INDESIT company

Model type:
BAAN10

Commercial code:
F033938

N1030093fig1

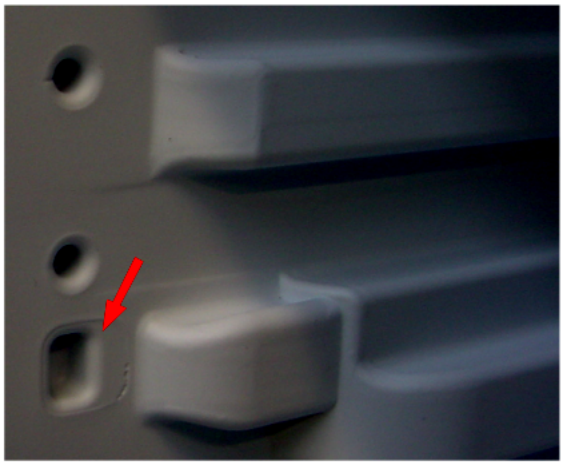
From August 05 (serial no. 50802.0001) the freezer evaporator is secured to the cabinet by a plastic profile.
The cabinet walls have been modified to create locations to house the profile, which is installed on the front of each evaporator plate (see photo N1030093fig1- fig2 - fig3)
The profile cannot be fitted on premodification appliances, so technical personnel must continue to fit the rh and lh supports on these models (see photo N1030093fig4)

New parts
C00141135 = WHITE PROFILE L=443.5 MM

Parts replaced
C00075596 = EVAPORATOR RH SUPPORT
C00075597 = EVAPORATOR LH SUPPORT

N1030093fig1

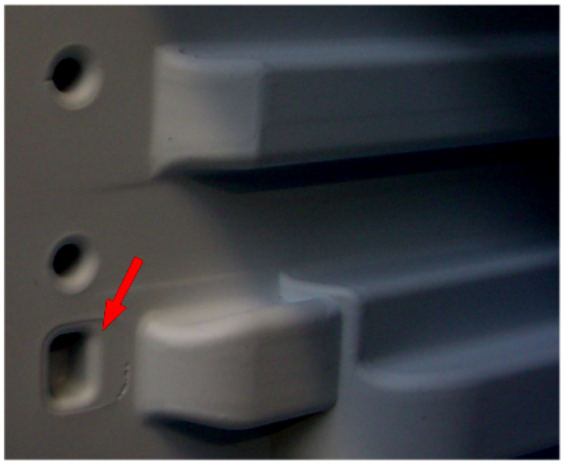
From August 05 (serial no. 50820.0001) the freezer evaporator is secured to the cabinet by a plastic profile.
The cabinet walls have been modified to create locations to house the profile, which is installed on the front of each evaporator

plate (see photo N1030093fig1- fig2 - fig3)
The profile cannot be fitted on premodification appliances, so technical personnel must continue to fit the rh and lh supports on these models (see photo N1030093fig4)

New parts
C00141135 = WHITE PROFILE L=443.5 MM

Parts replaced
C00075596 = EVAPORATOR RH SUPPORT
C00075597 = EVAPORATOR LH SUPPORT
